Project: PGT Main Plant Parking Lot Renovations
Site and Development Plan Amendment Petition No. 94-01SP.2
Special Exception Petition No. 17-09SE
Staff Report

Summary of Site and Development Plan:

Summary of Special Exception Petition:

Figure 1: Proposed Site Plan Drawing

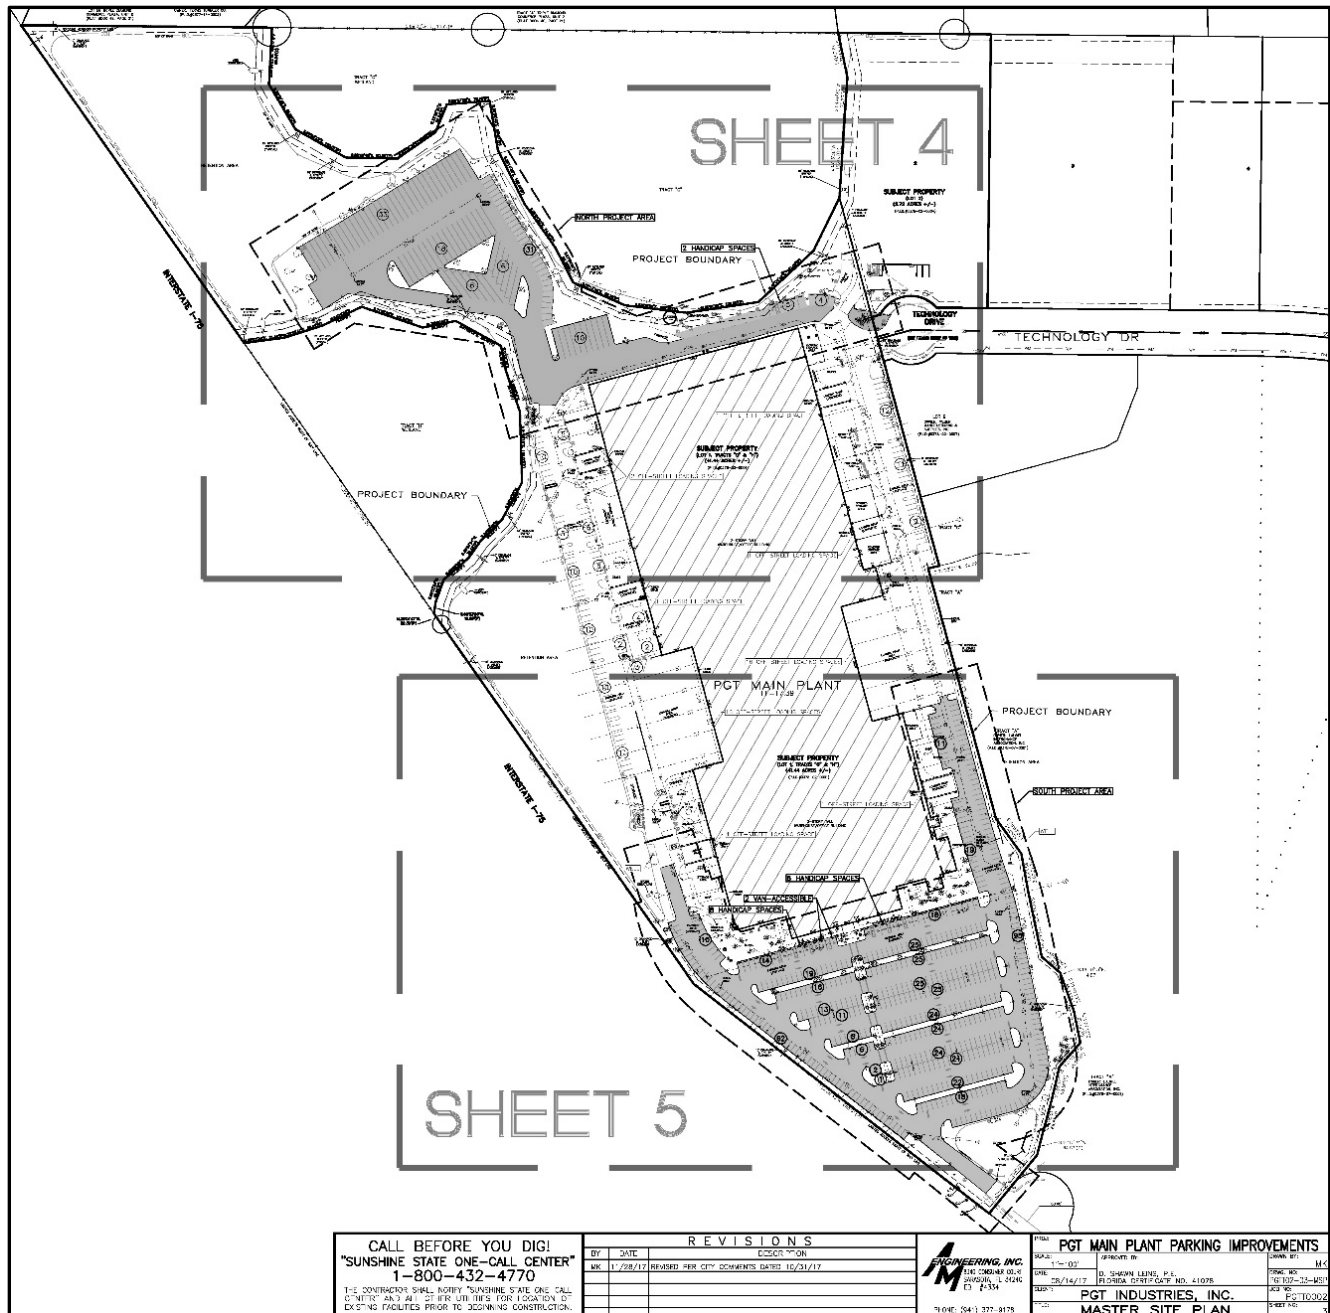
Section 86-411(8) requires a minimum five-foot wide landscape area between abutting rows of parking spaces. The site plan shows two instances, in the parking area on the south side of the PGT Main Plant, where abutting rows of parking spaces are not separated with a landscaped area.

In the parking area south of the PGT Main Plant there are five abutting rows of parking spaces. The applicant proposes to not provide the required landscape area between two of the five abutting rows of parking spaces. The requested code modification is mitigated, in part, by the width of the three proposed landscape areas. Based on the design of the parking, the three landscaped areas are required to have a minimum width of seven feet. The proposed site plan shows each of the landscape areas are 8.7 feet wide which is 24% greater than the minimum width. In addition, the parking areas are designed in compliance with Section 86-438 which establishes the minimum landscaping within the interior of parking facilities.

Section 86-411(10) requires parking spaces to have curb or motor vehicle stops or similar devices to prevent vehicles from overhanging on or into adjacent property, or from encroaching into required landscaped areas. The same abutting rows of parking, not separated by a landscaped area, also do not have curb or wheel stops.

This code modification applies to 122 parking spaces in the parking area on the south side of the PGT Main Plant. These parking spaces are designed in compliance with Section 86-412 which requires off-street parking spaces to have a minimum depth of 18 feet.

Section 86-412(a) requires that each parking space shall be a minimum of ten feet in width. Of the 697 proposed employee parking spaces, 673 of the spaces are designed at nine feet wide.
